Work Order ID 90088

Item Name: Crosstube Aft

DART SERVICE INSTRUCTION

DRAWING NO. D212-664-241	TITLE CROSSTUBE ASSY (205/212 HI AFT)	REV. D	DART AEROSPACE LTD ENGINEERING ORDER		D.E.O. NO. D212-664-241-D-1	SHEET NO. SHEET 1 OF 2	SCALE NTS
DRAWN	CHECKED	MFG. APPR.	APPROVED	DE APPR.			
DATE 11.04.07	DATE 11.04.11	DATE 11.04.12	DATE 11/04/12	DATE 11.04.12

FIGURE 1: SUPPORT INSTALLATION

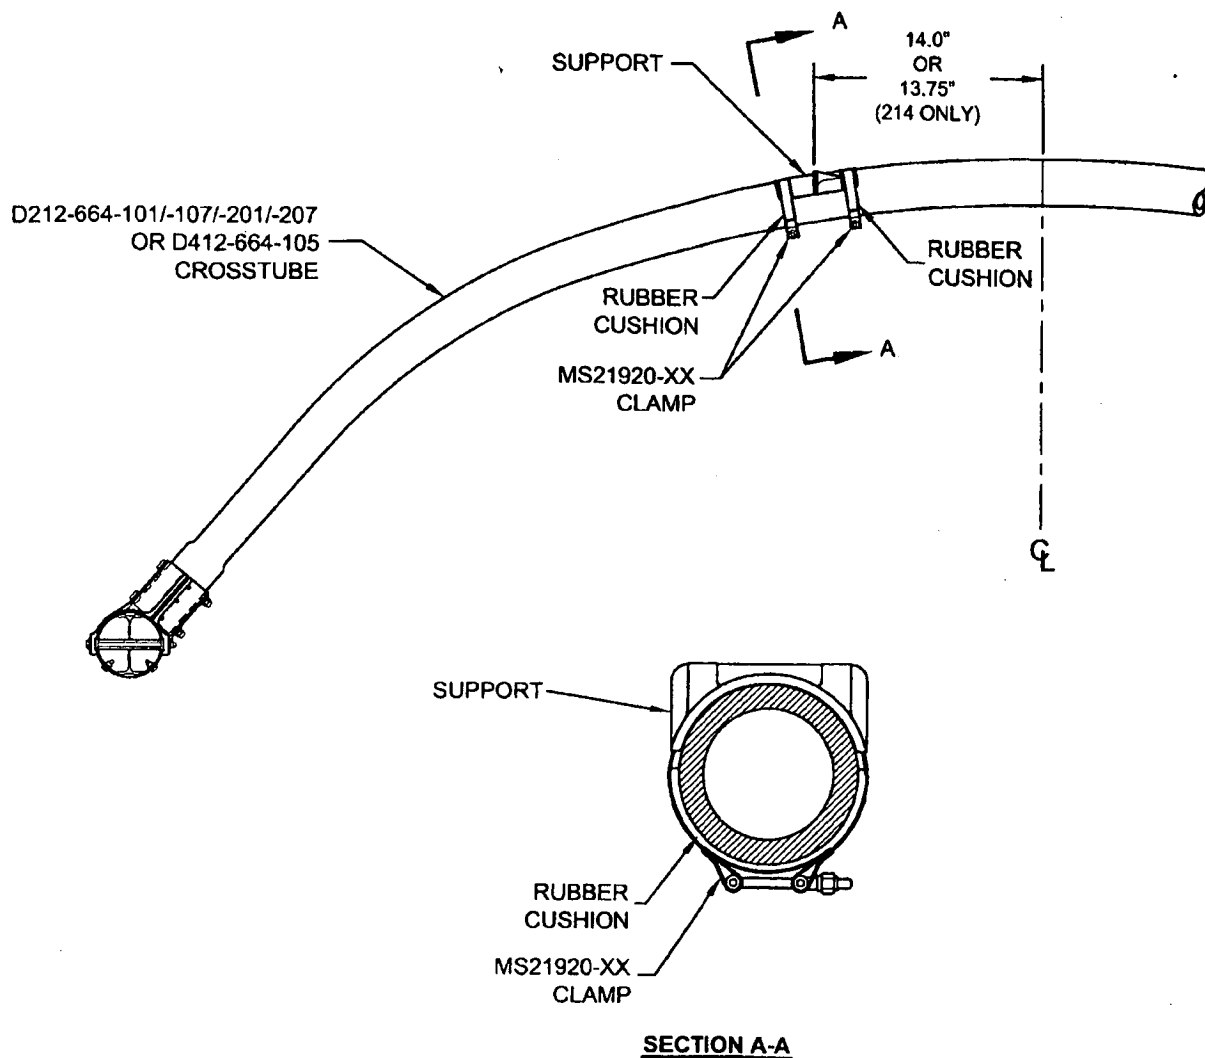
The supports on the following crosstubes are now installed using Proseal instead of Magnobond:

For the crosstubes listed above, section 32.4 of ICA-D212-664 is amended as follows. Use Figure 1 of this service instruction and Figures 32-2 to 32-9 of ICA-D212-664 for further reference. For crosstubes of an earlier change number, it is recommended that if the supports are removed, the supports should be reinstalled using the procedure listed below.

- 32.4.1 Locate the area on the crosstube for installation of support (see Figure 1 of this service instruction). For D212-664-101/-107/-201/-207 and D412-664-105 crosstubes, the outward face of the support tabs should be 14.0" (355mm) from the crosstube center for 204/205/210/412/UH-1 aircraft. For installation on 214B/B-1 aircraft, the outward face of the support tabs should be 13.75" (349mm). Ensure paint finish of crosstube is intact; touch up as required per Chapter 5 (5.3.9) of ICA-D212-664.

- 32.4.2 If present, remove any paint/primer on bottom of supports. Abrade mating surfaces of support and crosstube with 400-grit sandpaper. Saturate a clean cloth with MEK or 4105S Wash'n'Wipe Degreaser or equivalent and wipe until there is no residue.

- 32.4.3 Ensure a layer of 3M Scotch-Weld 2216 B/A Epoxy Adhesive is on the bottom of the support. If required, either apply or touch-up support to have a 0.03" to 0.05" thick layer of adhesive over the entire mating surface. Allow supports to cure for 24 hours.

- 32.4.4 Abrade mating surfaces of support (after cure) and crosstube with 180-grit sandpaper. Saturate a clean cloth with MEK or 4105S Wash'n'Wipe Degreaser or equivalent and wipe until there is no residue.

- 32.4.5 Apply a 0.04" to 0.07" thick layer of Proseal 890 Class B or AMS-S-8802 Class B sealant underneath applicable support and install support as shown in Figure 1 of this service instruction.

- 32.4.6 Install the clamps opposite to crosstube support as shown in section A-A of Figure 1. Install rubber cushions underneath each clamp around the bottom circumference of the crosstube up to the crosstube centerline. Torque clamps 80-100 in-lb (9.0-11.3 Nm). It is acceptable to use smaller or larger sized MS21920-XX clamps than those listed in ICA-D212-664, ensure that after torquing the clamps per this instruction, the nuts are in safety but not bottomed out

- 32.4.7 Prior to installing crosstube on aircraft, allow supports to cure for 72 hours and recheck torque on clamps.

**D212-664-241/-241B
ASSEMBLY DETAIL**

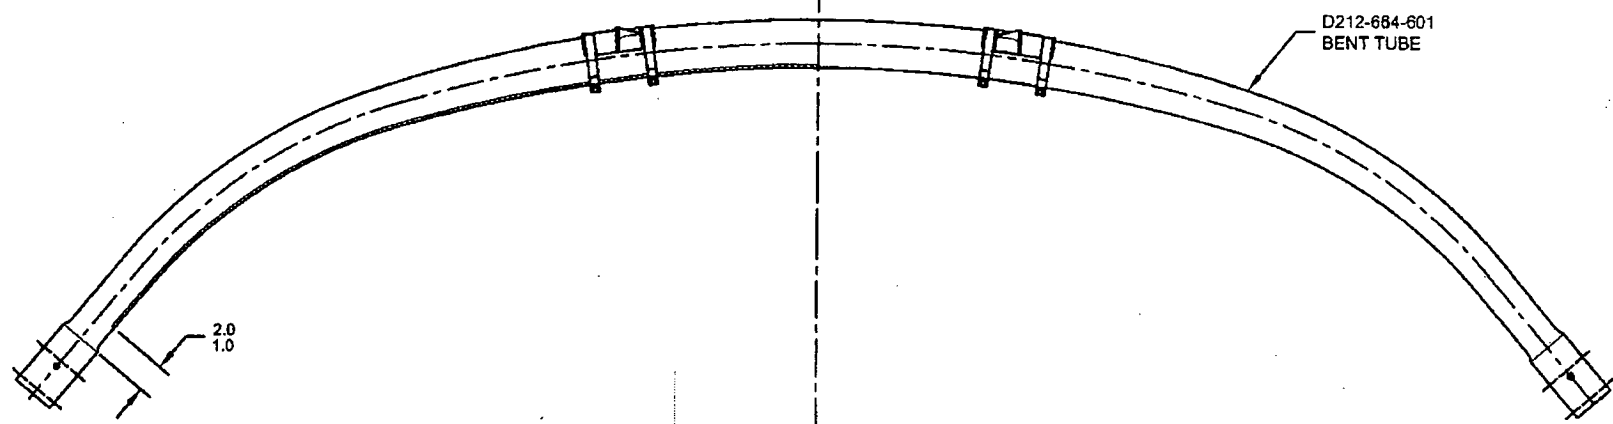
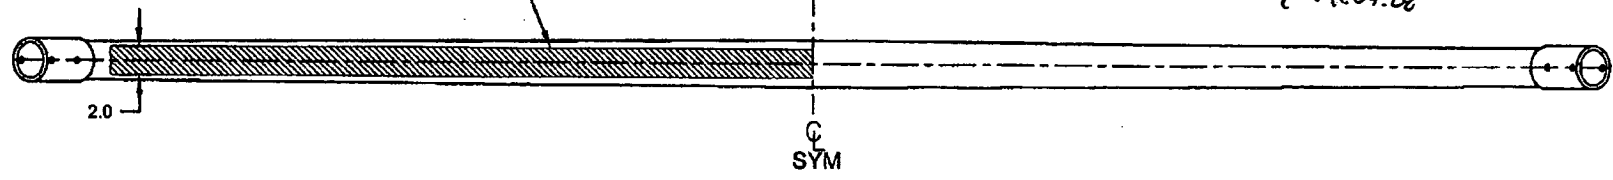
ADD AN INSPECTION WINDOW TO UNDERSIDE OF CROSSTUBE.

NOTES 2 OF SHEET 1 IS AMENDED AS FOLLOWS:

- 2) FINISH: CHEMICAL CONVERSION COAT PER DART QSI 005 4.1
PRIME INSIDE AND OUTSIDE PER DART QSI 005 4.2
MASK UNDERSIDE OF CROSSTUBE AS SHOWN (HATCHED AREA) AND
PAINT OUTSIDE PER DART QSI 005 4.2
REMOVE MASKING AND APPLY CLEAR COAT

MASK AREA PRIOR TO PAINTING,
REMOVE MASKING AFTER PAINT
AND APPLY CLEAR COAT

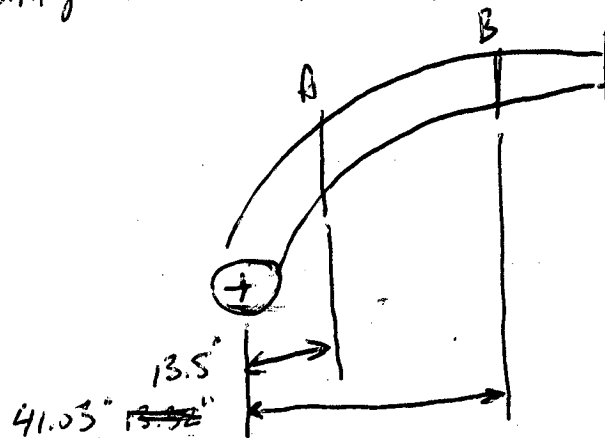
REPLACE MAGNOBOND WITH PROSEAL.

NOTE 12 & 15, SHEET 1 IS AMENDED AS FOLLOWS:

- 12) TO INSTALL D2940-1 SUPPORT: ABRASE MATING SURFACE OF SUPPORT AND CROSSTUBE WITH 180-GRIT SANDPAPER AND REMOVE RESIDUE WITH MEK (OR EQUIVALENT). APPLY A 0.04" TO 0.07" THICK LAYER OF PROSEAL 890 CLASS B-2 (OR AMS-S-8802 CLASS B-2) SEALANT TO MATING SURFACE OF SUPPORT.
- 15) TORQUE CLAMPS 80 TO 100 IN-LB. ENSURE AT LEAST 1.5 THREADS SHOWING IN SAFETY AND THAT NUT HAS NOT BOTTOMED-OUT AFTER TORQUING. **PRIOR TO PACKAGING, RE-CHECK TORQUE ON CLAMPS AFTER PROSEAL 890 SEALANT HAS CURED FOR 72 HOURS.**
